## ORIGINATION FORM

Proposed Revisions to a Standard Plans Index  
(Please provide all information — Incomplete forms will be returned)

Index Number: 400-010

Index Title: Cantilever Retaining Wall

LAST REVISION 11/01/17	REVISION	DESCRIPTION:		FY 2020-21 STANDARD PLANS	CANTILEVER RETAINING WALL (C-I-P)	INDEX 400-010	SHEET 1 of 2
---------------------------	----------	--------------	--	------------------------------	-----------------------------------	------------------	-----------------

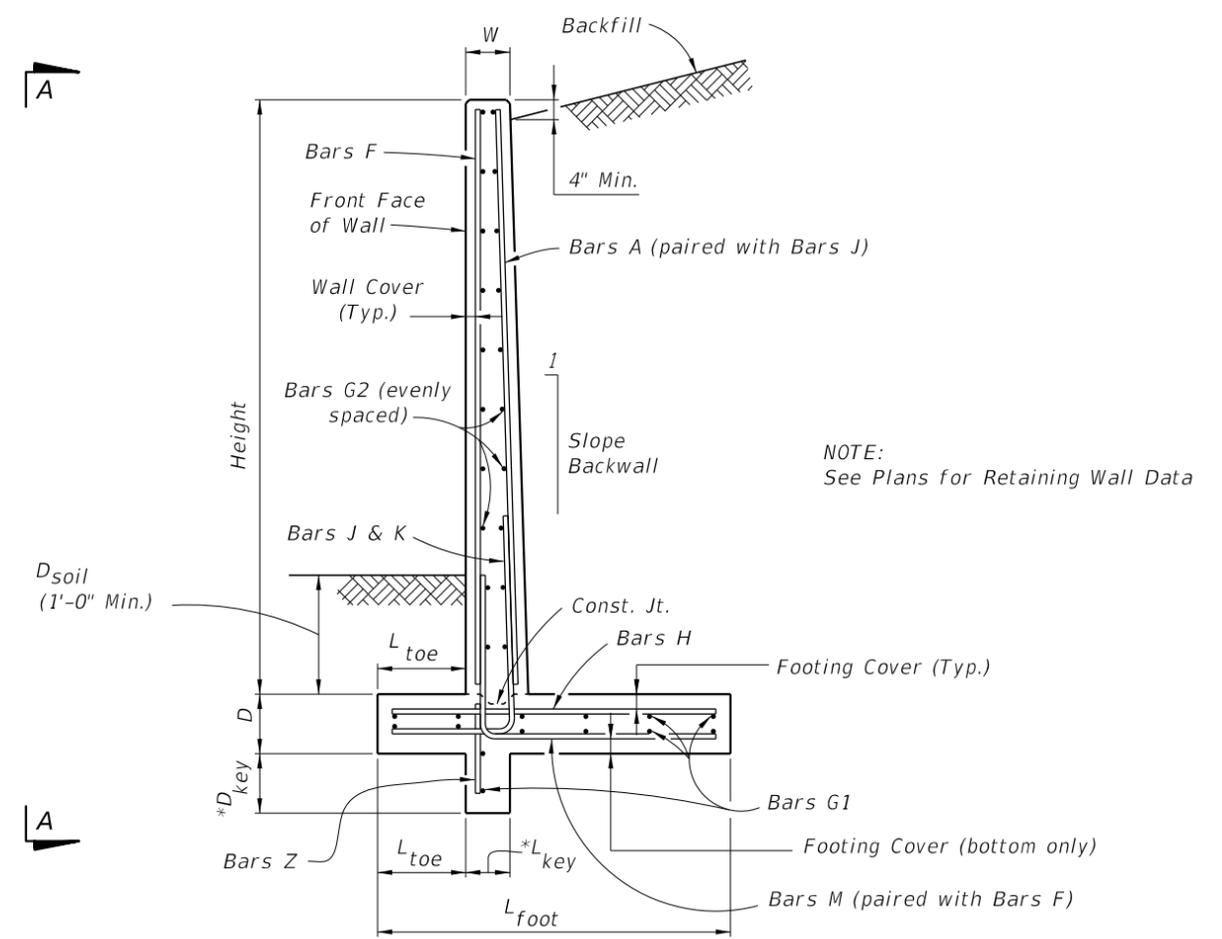
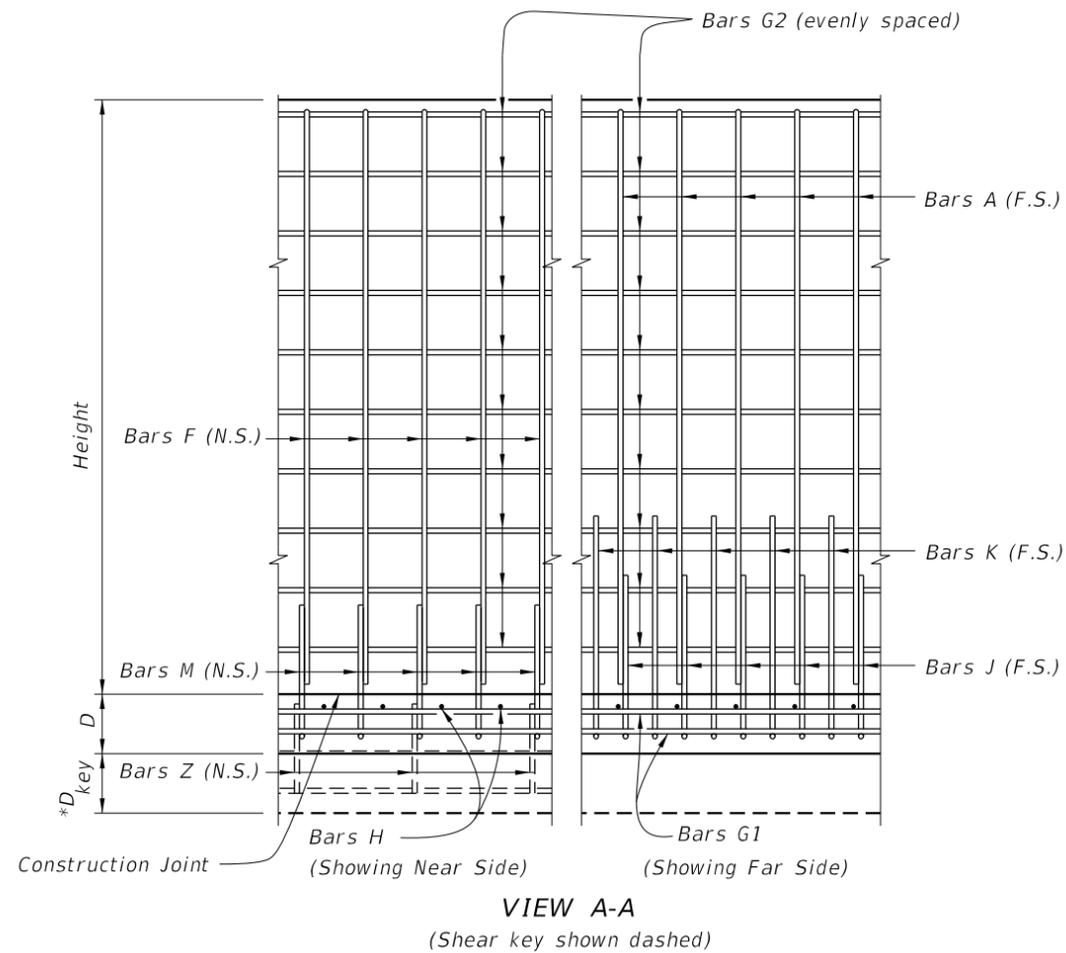
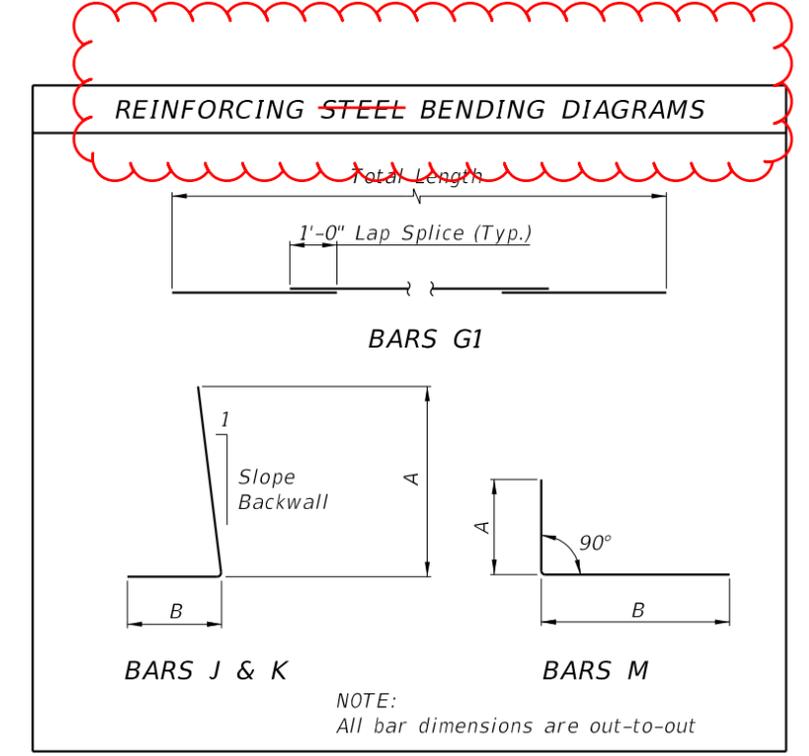
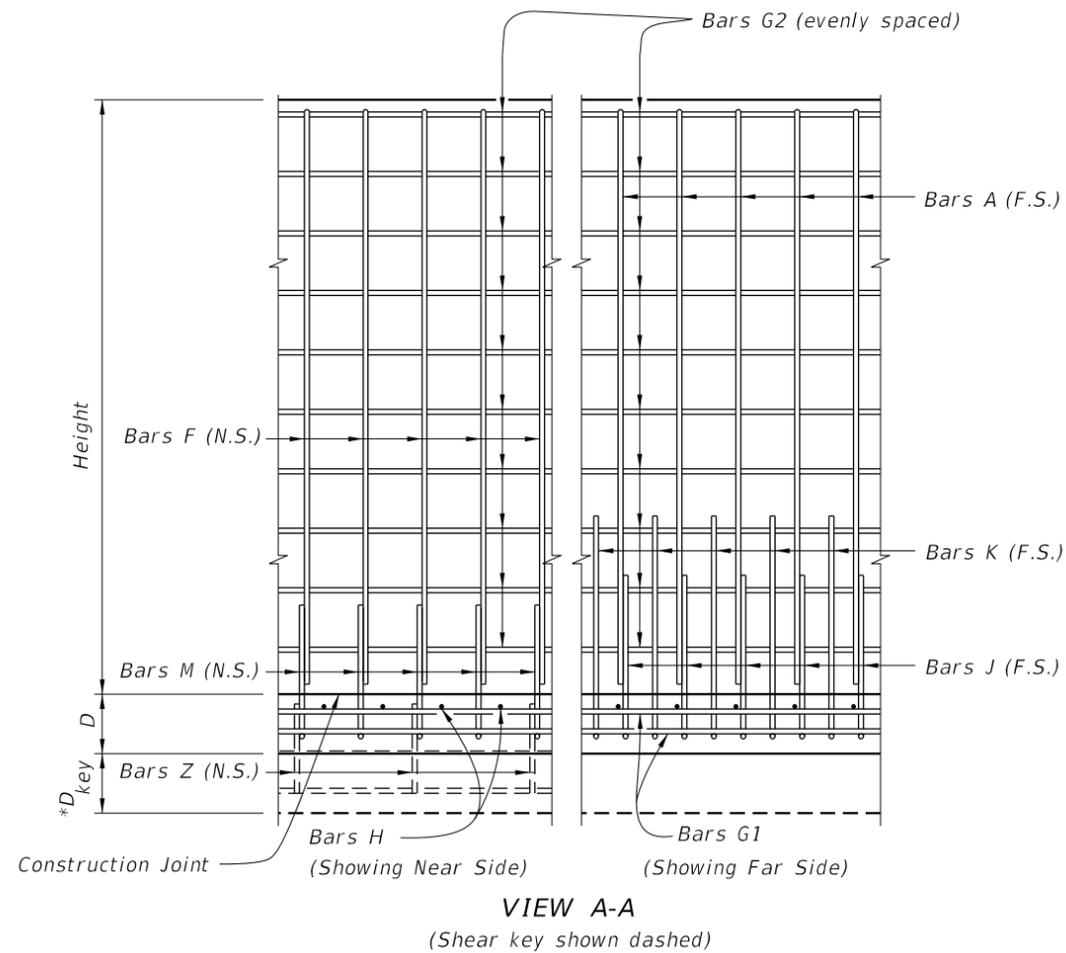
Remove reference to steel for reinforcement

Make generic for Steel or GFRP/BFRP reinforcing

LAST REVISION 11/01/20	DESCRIPTION:	 FY 2020-21 STANDARD PLANS	CANTILEVER RETAINING WALL (C-I-P)	INDEX 400-010	SHEET 2 of 2
---------------------------	--------------	--	-----------------------------------	------------------	-----------------

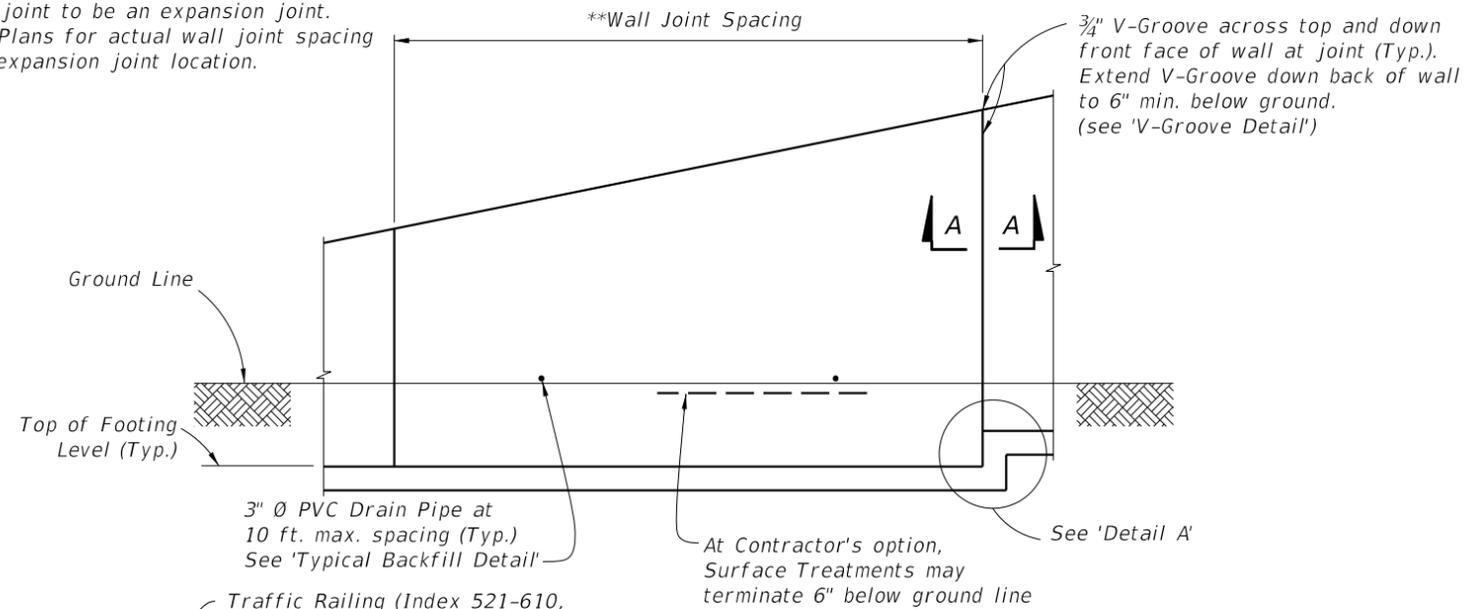
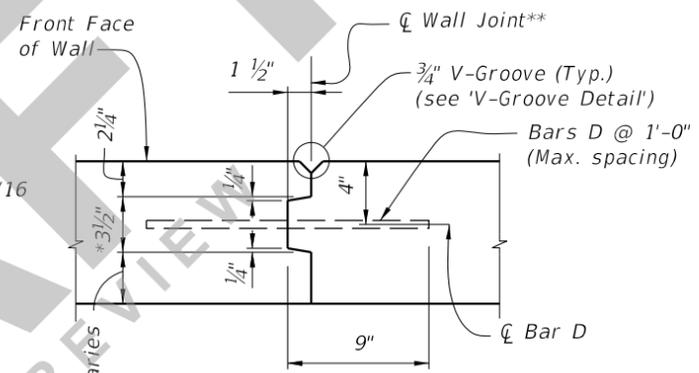
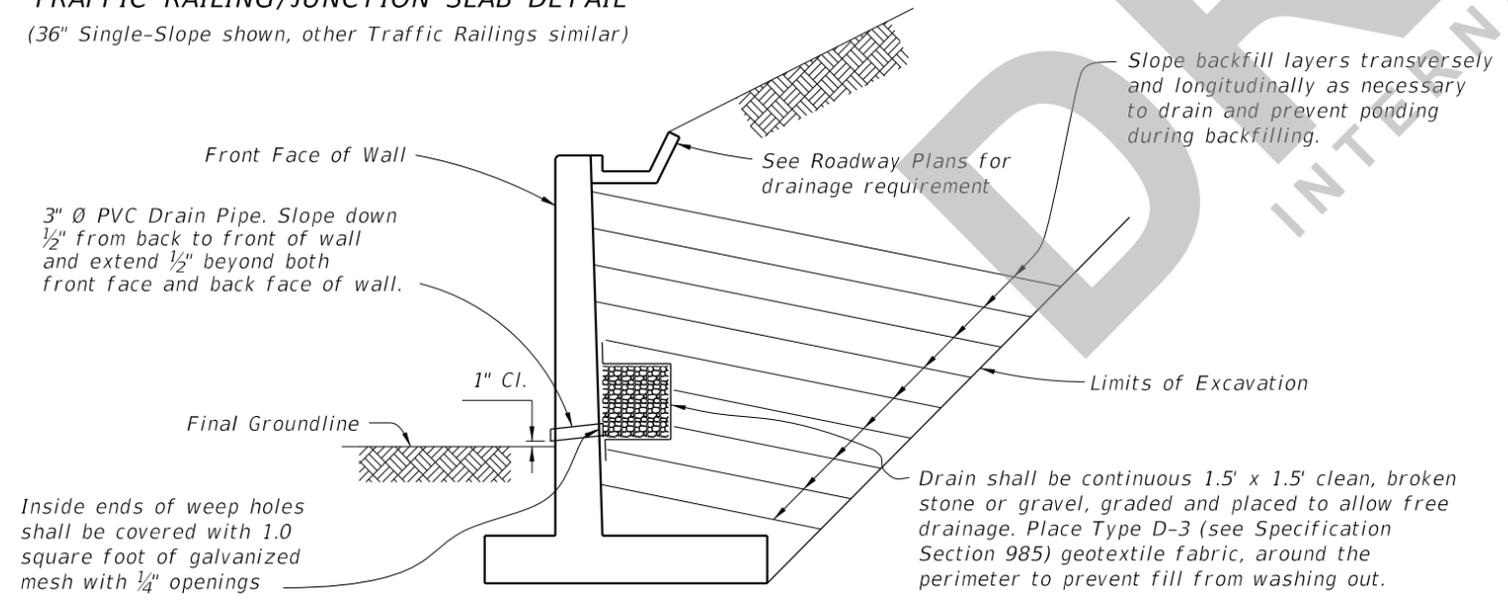
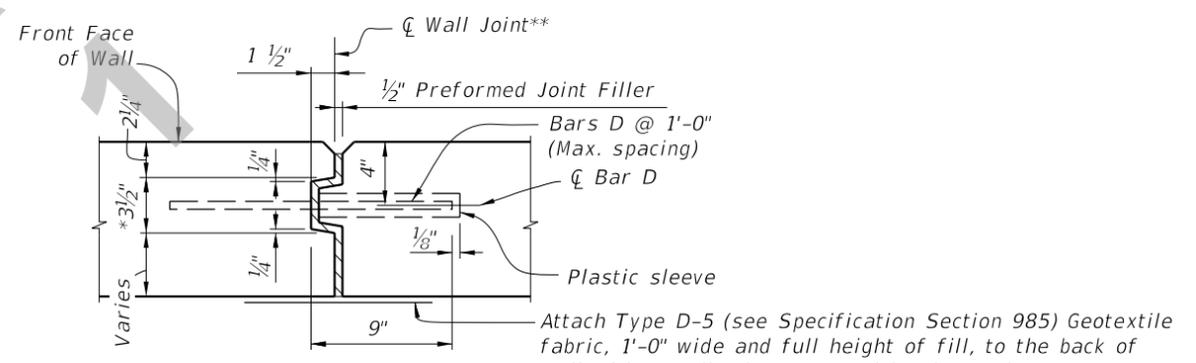
- \* Key to stop at top of footing and 6" from top of wall. Joint across footing and top of wall to be a straight line.
- \*\* Stay-In-Place Plastic Preformed Bond Beakers are permitted to form joints.
- \*\*\* Bars D: Where a bend is required to maintain clearances, submit bend angle to GFRP supplier; steel reinforcing may be field bent.
